October 13, 2025

This addendum forms a part of the contract documents and modifies the original bid documents for the project.

DRAWINGS**AD5.03 C-506 WATER STORAGE TANK (1 OF 2)**

PROJECT :
CITY & BOROUGH OF YAKUTAT
WATER SYSTEM EXTENSION
YAKUTAT, ALASKA

SHEET TITLE :
WATER STORAGE TANK
DETAILS (1 OF 2)

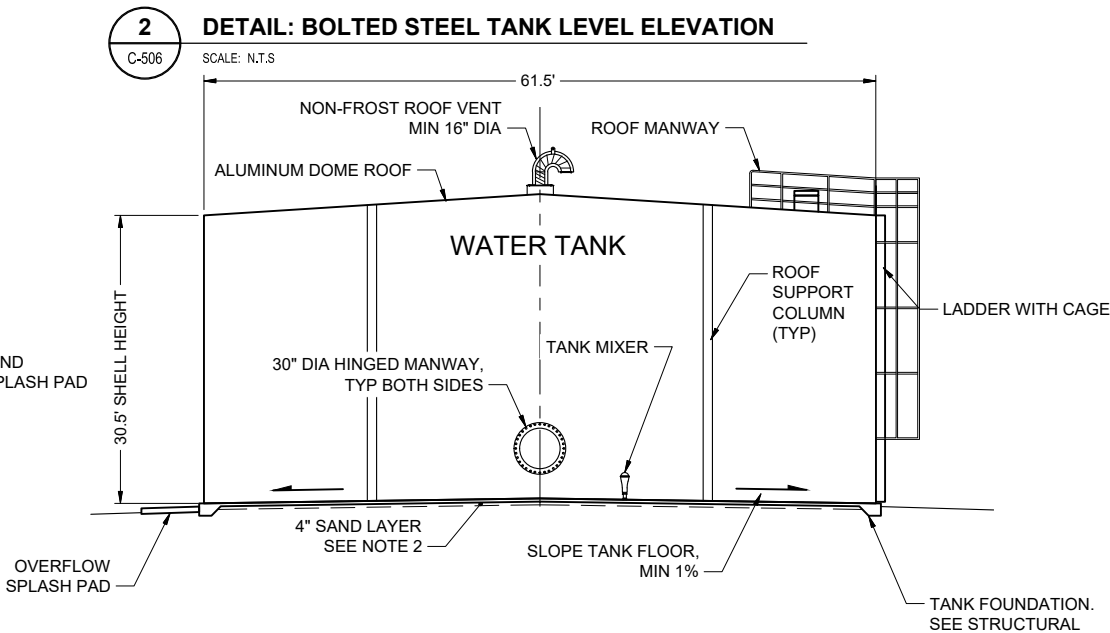
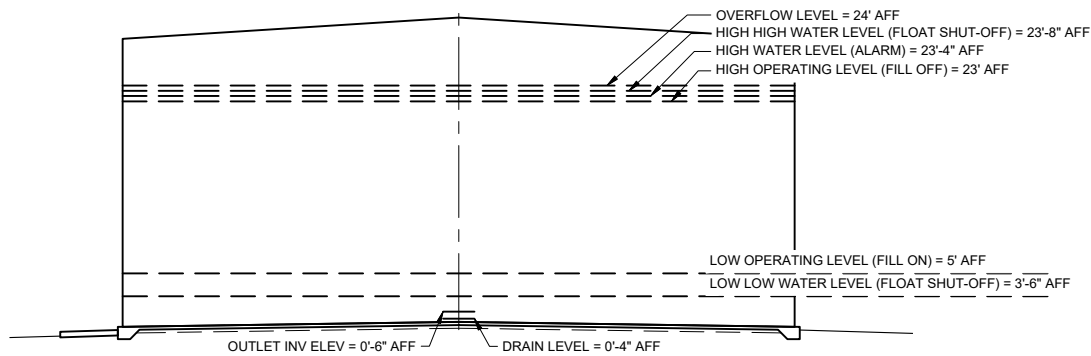
1. **QUESTION:** After receipt of Addendum 4, we reached out to two tank suppliers to see if they can adhere to the requirements called out in the Addendums 3 & 4. The two issues are the 1/8" corrosion allowance in addendum 3 & 4 and the cathodic protection requirement in Addendum 3. Both suppliers would need to take exception to the 1/8" corrosion allowance requirement, and they reference that the corrosion allowance is part of a welded steel tank specification. Also, neither of the suppliers can, or are willing to supply a CP system with that will adhere to the requested 50 Year life span. See attached document from CST Industries. Finally, in the Bid documents there is not a location that I can take exception to the referenced items, while requiring us to state we can adhere to all the Plans and Specs in the Article 6 -Bidder's Representation and Certifications A.9. If our suppliers cannot and adhere to the Plans, Specs, and Addendums, then it is problematic. Please either include a line for exceptions taken in the bid document, or remove the requirements for Corrosion Allowance and CP on the Bolted Steel Water tank.

RESPONSE: The corrosion allowance and cathodic protection requirement for the tank have been deleted. Coating System has been updated in the specs.

C-507

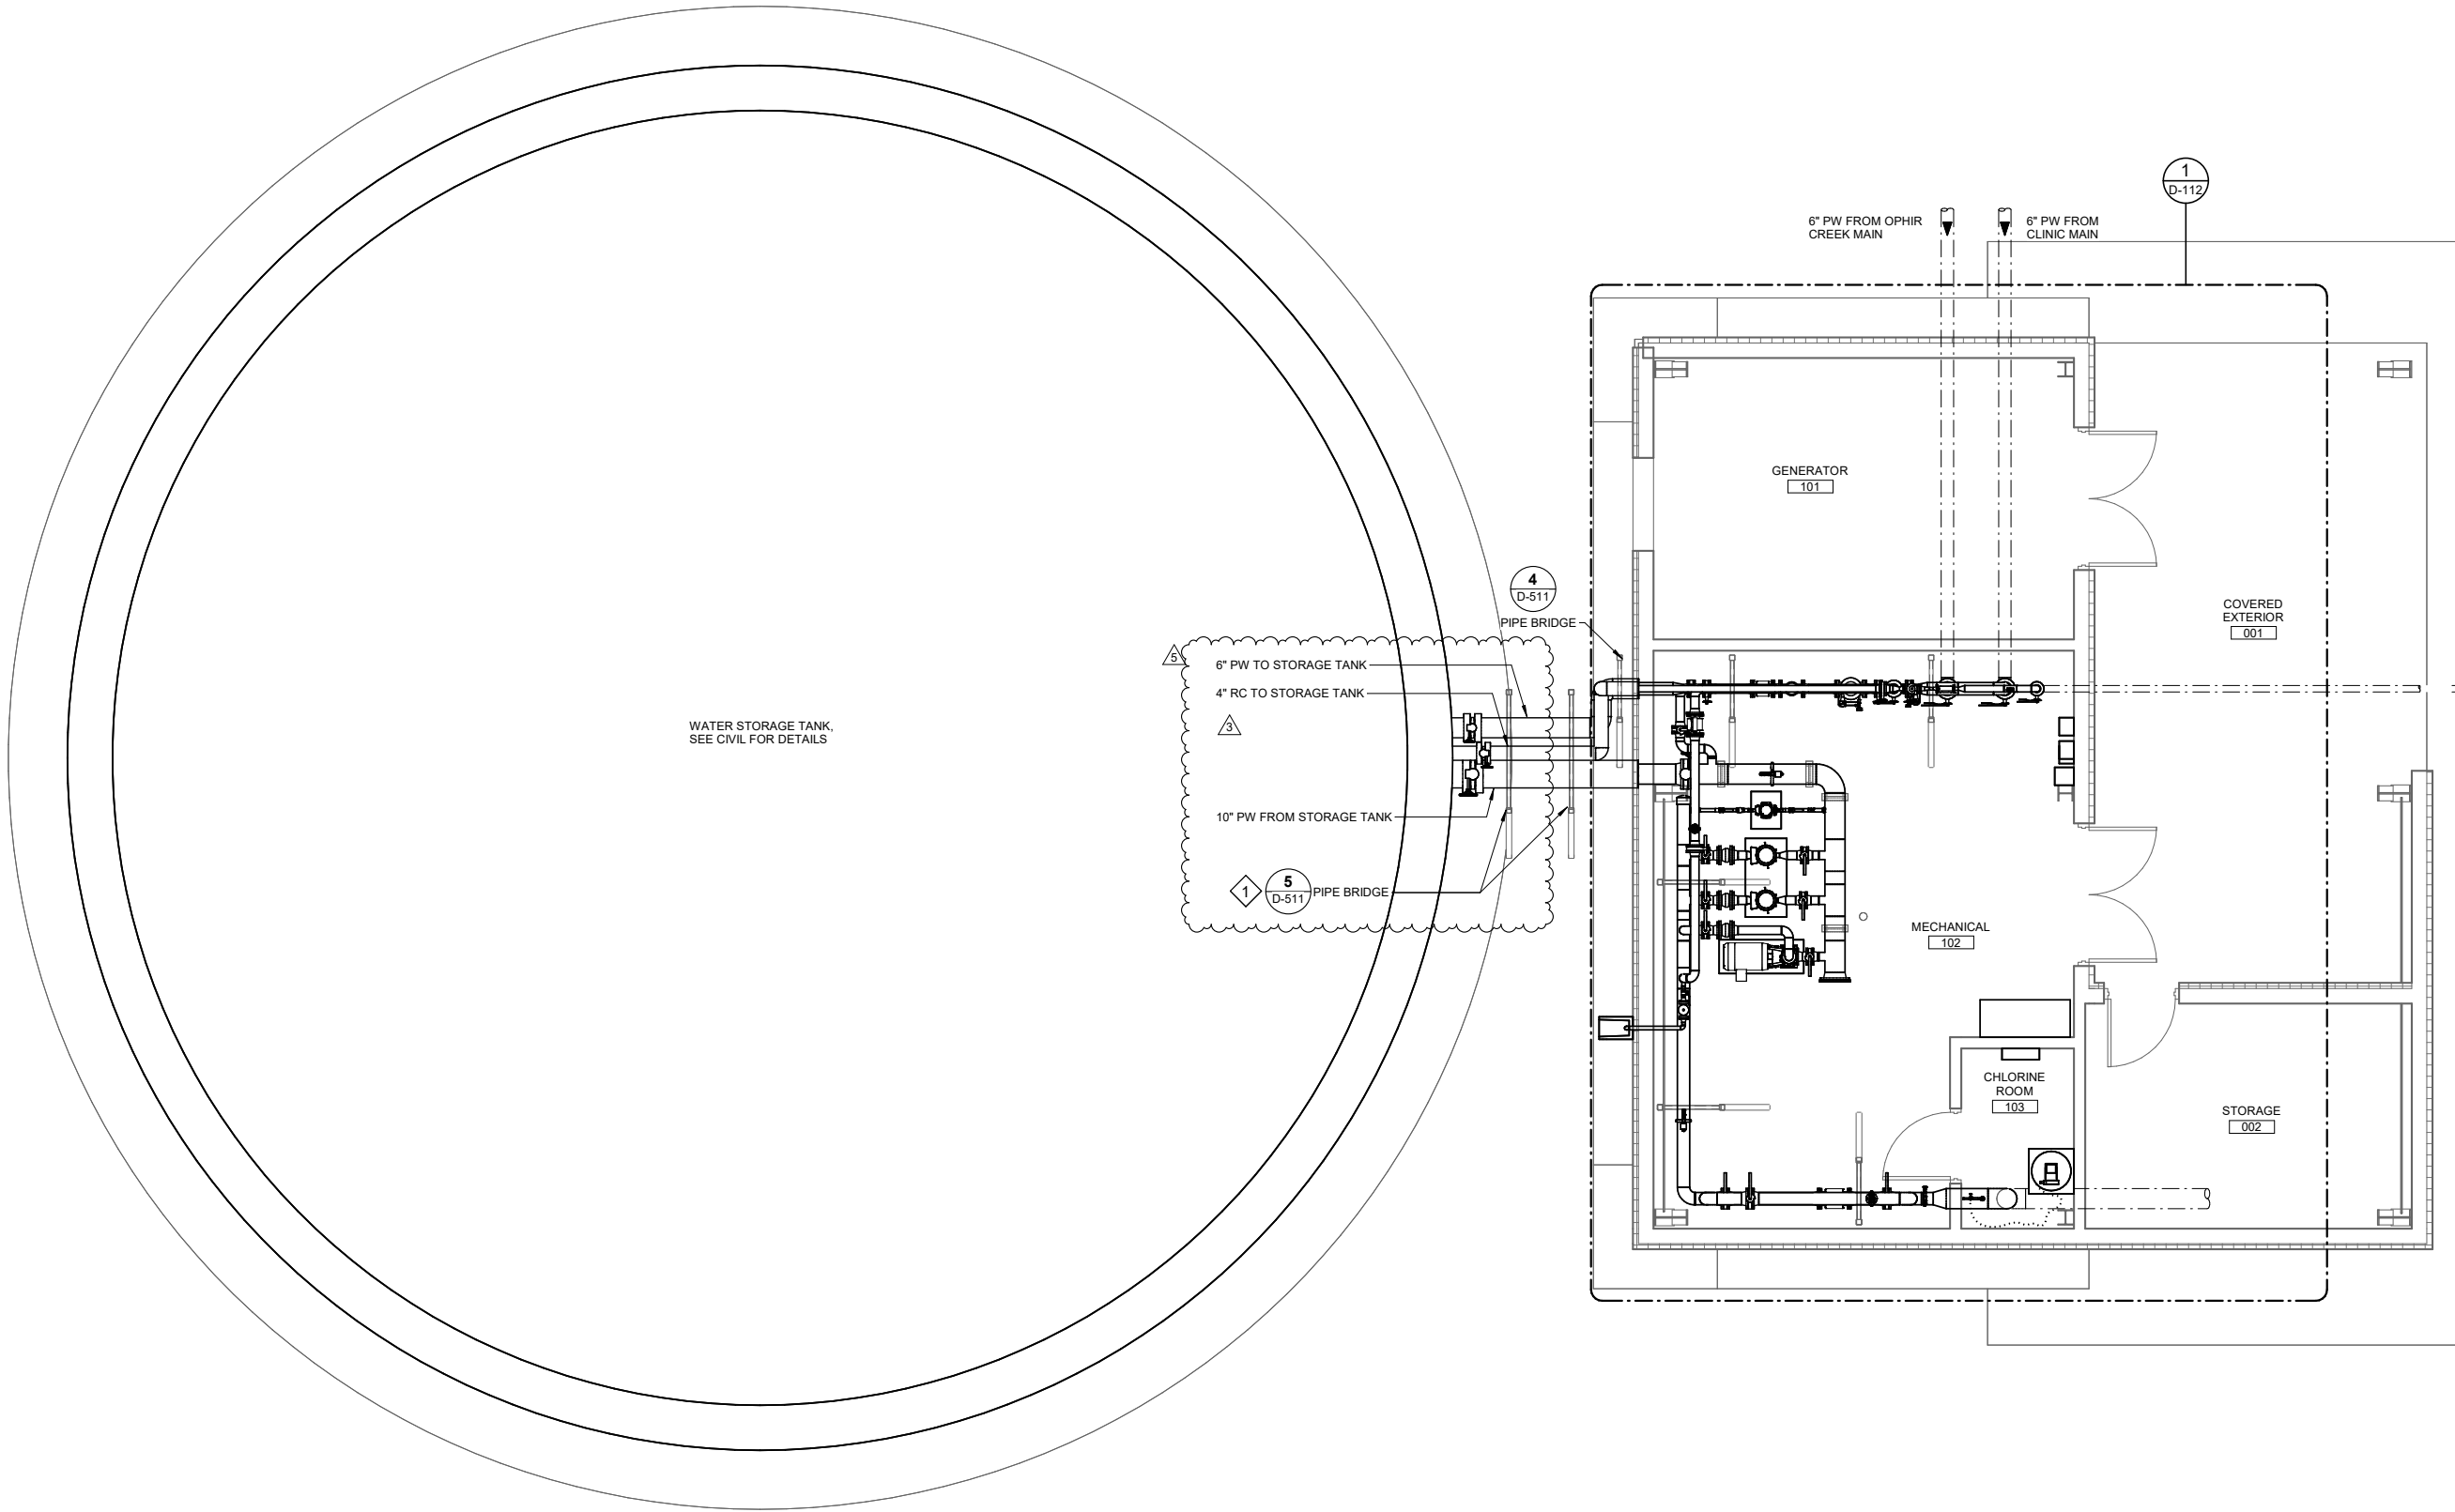
2. **QUESTION:** Concern about piping between pumphouse and water storage tank. The FlexTEND and other fittings will not fit in this space. Also, the pipe stands are called out at 36" spacing but the FlexTEND is longer than that. The expansion length was not specified in the plans/specifications. The expansion length impacts the overall length of the fitting. From the Base drawing, we have 8 feet between the tank wall and the pumphouse wall. Could you please look into this?

RESPONSE: The FlexTend fitting will not meet the space limitation between the pipe bridge and the tank. Bridge spacing per drawing D-511 shows 2'-3" between the tank and the pipe bridge; this has been revised to provide additional space for valving. Drawing C-507 has been revised with an alternative expansion joint basis of design (Garlock Style 204) that requires less space. The expansion joint shall provide minimum 1-in lateral deflection and accommodate 0.06-in horizontal movement concurrently. Language has been added to specification 331613 Section 2.06 b to provide requirements for expansion fitting.

In addition, the gate valves have been changed to butterfly valves to provide additional space. The pipe bridge shall be field adjusted to accommodate valves and fittings as needed. Drawings C-507, D-111, and D-611 have been updated to reflect these changes.
